**Re: Halton Hills Hydro Inc.
Application for Rates
Ontario Energy Board File Number EB-2015-0074**

**Ontario Energy Board (OEB) Staff Interrogatories
Halton Hills Hydro Inc. (HHHI)
2016 Cost of Service - EB-2015-0074
December 4, 2015**

Figure 20 Age Distribution of In-Service Wood Distribution Poles

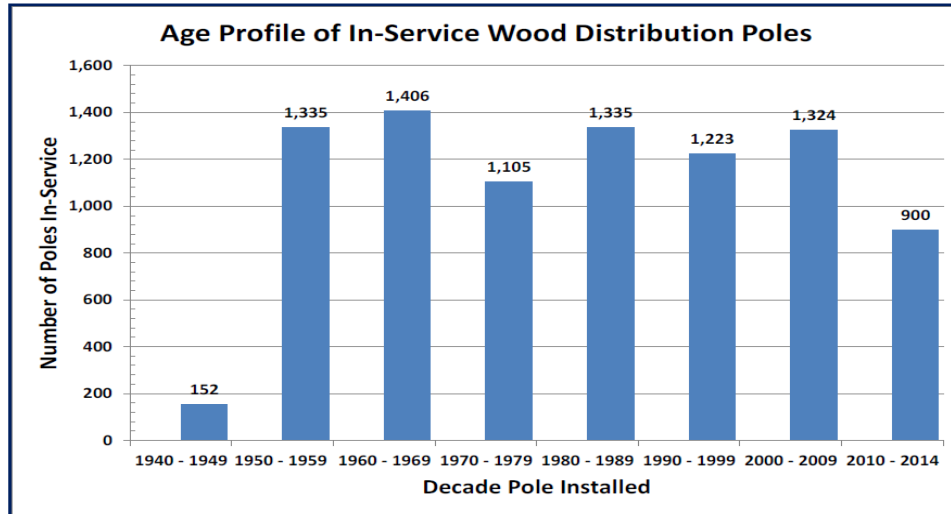
The application states, “As can be seen in the graph above, Halton Hills Hydro has 1400 poles exceeding their 50 year expected lifespan and an additional 1400 poles approaching end of life. Given this age profile, Halton Hills Hydro has implemented an accelerated pole replacement program targeting 275-280 distribution poles each year for the next ten years.”

HHLI has identified that it intends to implement a pole replacement program with a capital cost of \$2 million per annum for the next 10 years. Under this plan a total of between 2,750 and 2,800 poles will be replaced over the next 10 years, representing 31% - 32% of HHLI's pole portfolio. This number is nearly equal to the total number of poles assessed as being in "Fair" (26%), "Fair-Poor" (4%) and "Poor" condition (4%).

For an asset class such as wood poles with a 50-year actuarial "Useful Life", approximately 2% of HHLI's 8,780 wood pole portfolio (or approximately 175 poles) would need to be replaced each year over the longer term. HHLI plans to replace 275 to 280 poles, or just over 3% of its pole portfolio, per annum.

- c) Is the accelerated pace of the HHHI pole replacement program described in the DSP based primarily upon assessed pole condition or upon replacing poles that have exceeded the actuarial “Useful Life” threshold?

Figure 21 Pole Condition

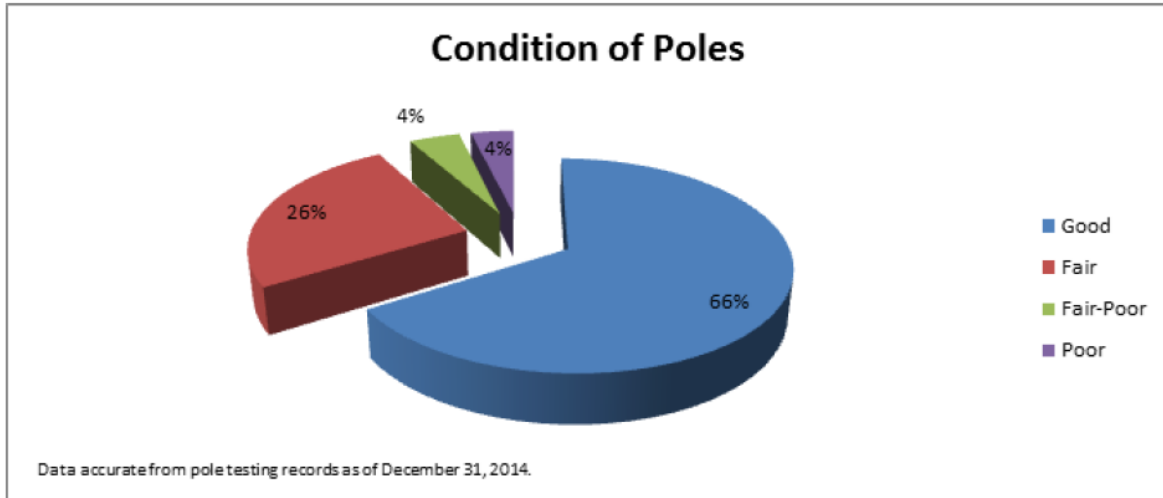
The application states, “As can be seen from the chart below, 34% of Halton Hills Hydro poles have some level of damage or wear.”

- d) Does HHHI consider “some level of damage or wear” to be an appropriate criterion to trigger pole replacement?
- e) How does HHHI determine which poles need to be replaced immediately? In other words, is there a separate category below “Poor” used to identify poles that require immediate replacement?

Figure 38 Ranking Scheme for Prioritizing Cable Replacement / Rejuvenation Projects

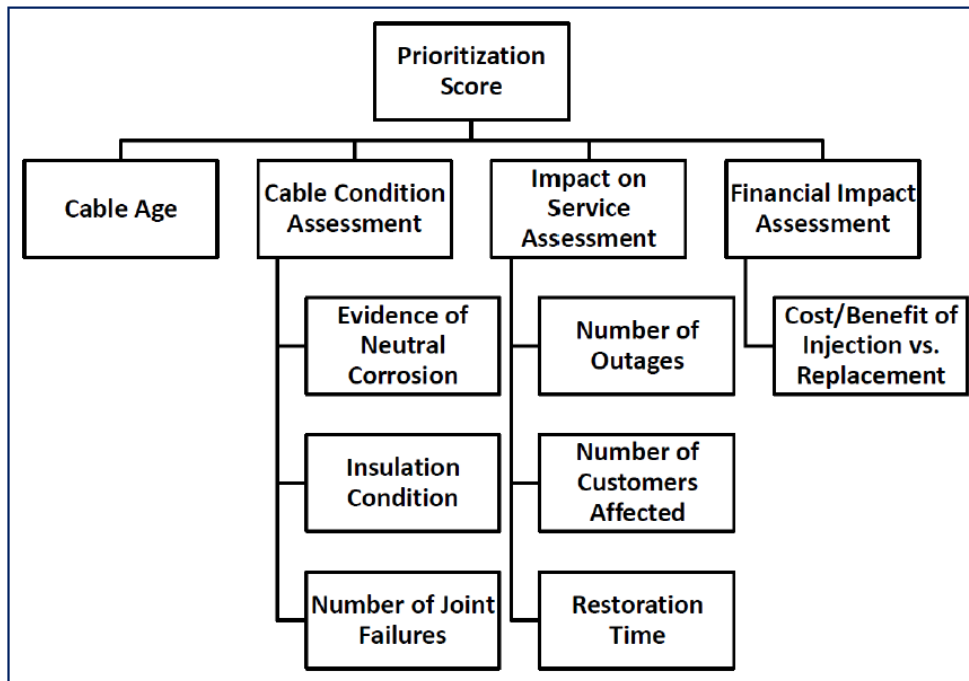
- a) How does HHHI determine that a particular underground cable requires or would benefit from injection treatment, prior to conducting the Financial Impact Assessment process step shown in Figure 38?

- b) Has HHHI developed a database to track underground cable failures by vintage, voltage, cable type or any other usefully indicative parameters, to help anticipate future cable failures, or to assist with planning preventive cable replacement or treatment projects?
- c) Please quantify the annual capital expenditure reductions achieved to date by adopting the Ranking Scheme shown in Figure 38.

Drivers for Over-Earning in 2014

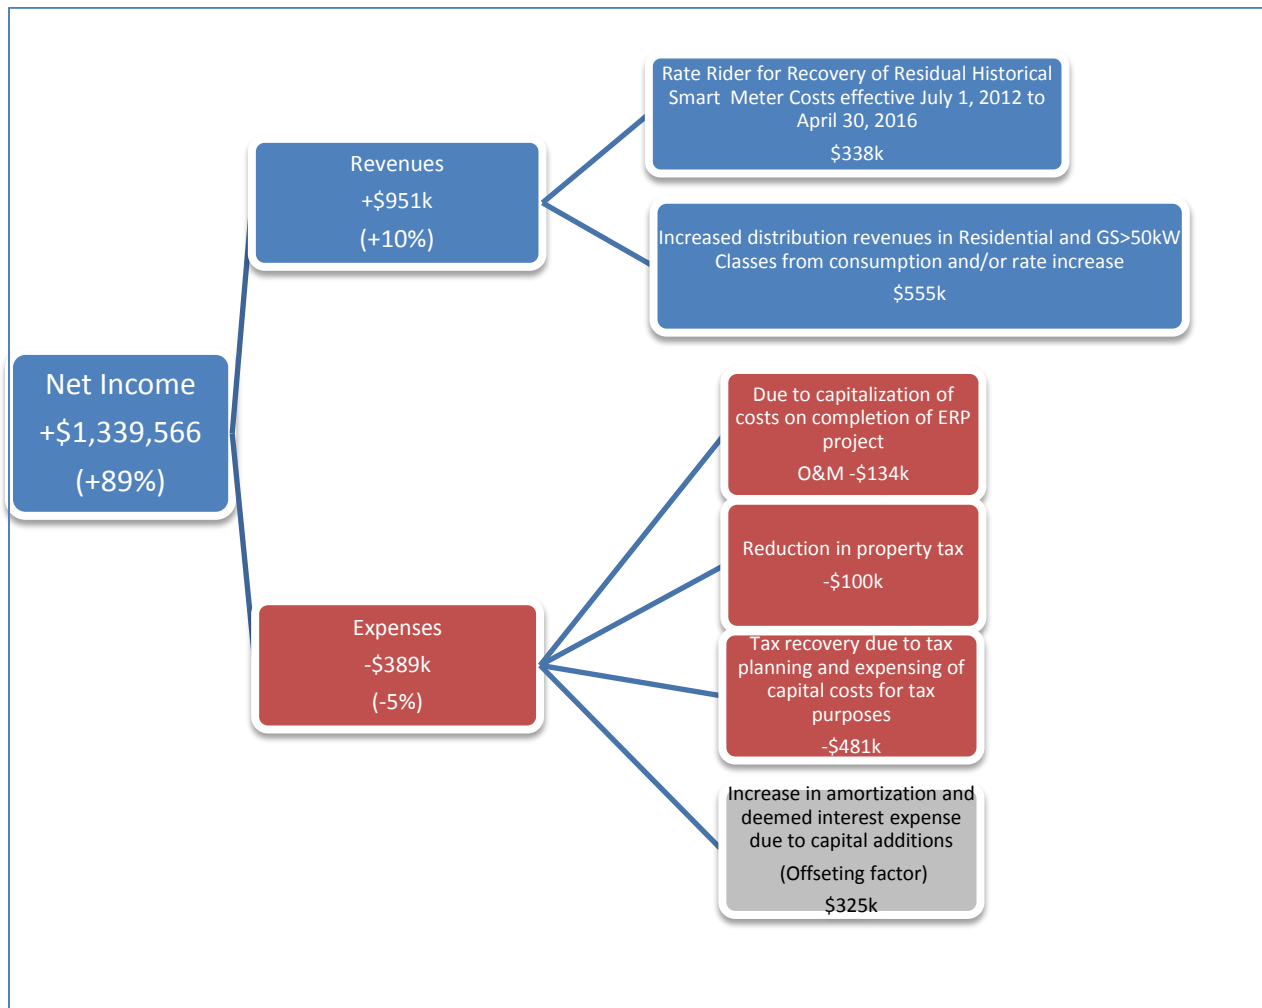
An analysis of 2014 return on equity is provided at Attachment 1 of these interrogatories.

- a) Please confirm the data.
- b) Will the tax planning and expense control driver and the revenue driver identified in this analysis of 2014 return on equity continue to persist?
- c) Please provide a forecast of 2015 ROE performance using the actual information from January 1 to November 30, 2015 and forecast information for December 2015.
- d) Please provide the return on equity performance results for 2015 adjusted for taxes.
